# UNITED STATES PATENT AND TRADEMARK OFFICE

APPLICATION NO.	FILING DATE	FIRST NAMED INVENTOR	ATTORNEY DOCKET NO.	CONFIRMATION NO.
10/573,560	03/27/2006	Wolfgang Haller	23496	7149

<b>Office Action Summary</b>	<b>Application No.</b>		<b>Applicant(s)</b>	
	10/573,560		HALLER, WOLFGANG	
	<b>Examiner</b>		<b>Art Unit</b>	
	Phuongchi Nguyen		2833

## DETAILED ACTION

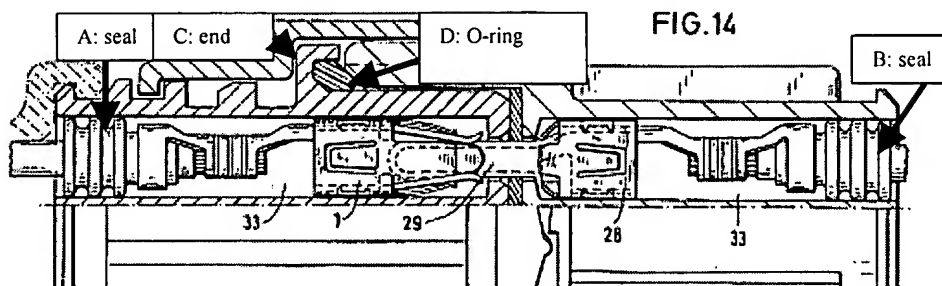
In regards to claims 1, 4 and 15, Zinn et al discloses (see fig. 14) a plug connector (assembly) comprised of a plug (of 34) with a plug housing (34), having at least one contact pin (29)(fig. 10), and comprised of a coupling (of 35) with a coupling housing (35) that has at least one contact sleeve (30)(fig. 1);

whereby the plug (of 34) and the contact pin (29) can be plugged at least partially into the coupling (of 35);

whereby the contact pin (29) and the contact sleeve (30) are each connectable by at least one crimp connection (3, 3) (figs. 1 and 10) with at least one cable connector of a cable (fig. 14),

whereby on the plug housing (34) and on the coupling housing (35), each respective seal (A, B) is provided against the outer jacket of the cable (see marked-up 1).

In regards to claim 5, Zinn discloses the plug connector characterized in that the plug housing (34) and the coupling housing (35) have a cylindrical enlargement in the region turned toward the cable and in which the seal (A, B) is set and fixed (see marked-up 1).

In regards to claim 9, in view of claim 5, the seal of Zinn must have one longitudinally extending spreading gap or opening for the cable going through (marked-up 1).

In regards to claim 12, Zinn discloses the plug connector characterized in that within the plug (34) or the coupling housing (35) are provided and that at the ends (C ) turned away from the cable have sealing rings (D) that correspond to the seals (A, B) between the plug housing (34) and the coupling housing (35) and the cable (see marked-up 1).

Figure 6  
C Marked-up 2

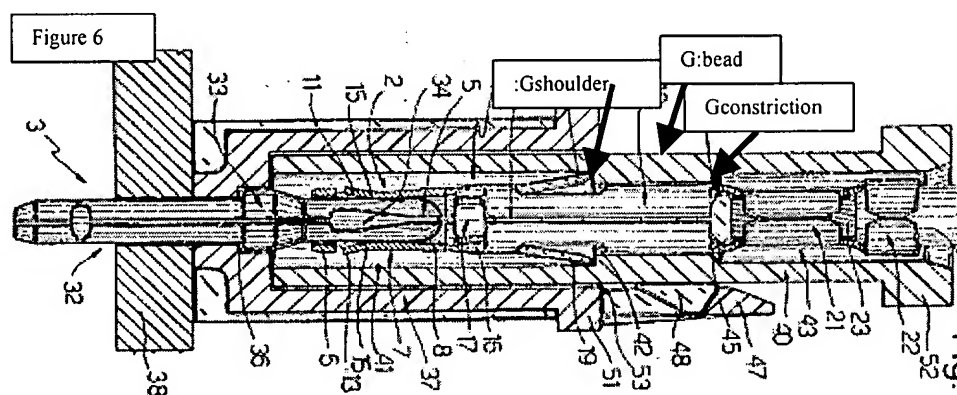
Zinn discloses the invention generally all as claimed, but lacks a locking part and detent hook. However, Galizia et al teaches the plug (of 37) and the coupling (of 40) each have a locking part (47, 48) of a locking unit for fixing the plug (of 37) and the coupling (of 40) relative to one another, and

whereby the contact pin (3) and the contact sleeve (1), the contact sleeve (1) have at least one detent hook (19) (figs. 2 and 6) that, upon insertion of the contact pin (3) and the contact sleeve (1) in the respective plug housing (37) and the coupling housing (40), the detent hook (19) engages behind a respective shoulders (G<sub>shoulder</sub>) therein (see marked-up 2) and; the shoulder is a component of the bead (G bead).

Marked-up 3 (figure 10 of Puerner)

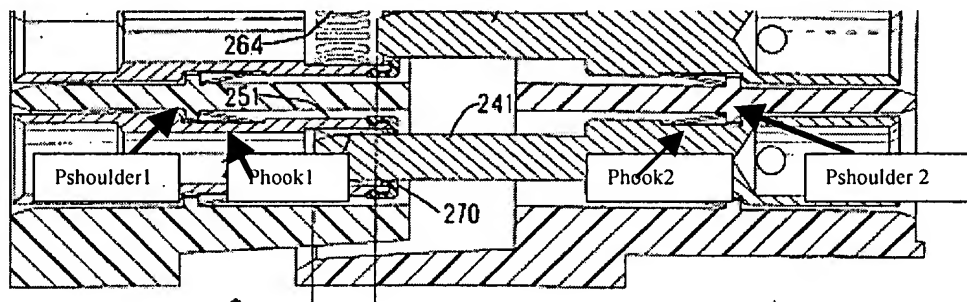
In regards to claim 2, Zinn discloses the invention generally all as claimed, but lacks a detent hook on the contact pin corresponding with the shoulder on the plug housing. However, Puerner teaches the plug connector characterized in that the contact pin (141) and the contact sleeve (151) each are formed with two, preferably diametrically oppositely arranged, detent hooks (Phook1, Phook2) and the shoulder (Pshoulder1, Pshoulder 2) is configured as an annular shoulder (PD) (see marked-up 2). It would have been obvious to one having ordinary skill at the time the invention was made to modify the plug connector assembly of Zinn et al by providing another detent hook as taught by Puerner on the contact pin for locking of the contact pin on the plug housing.
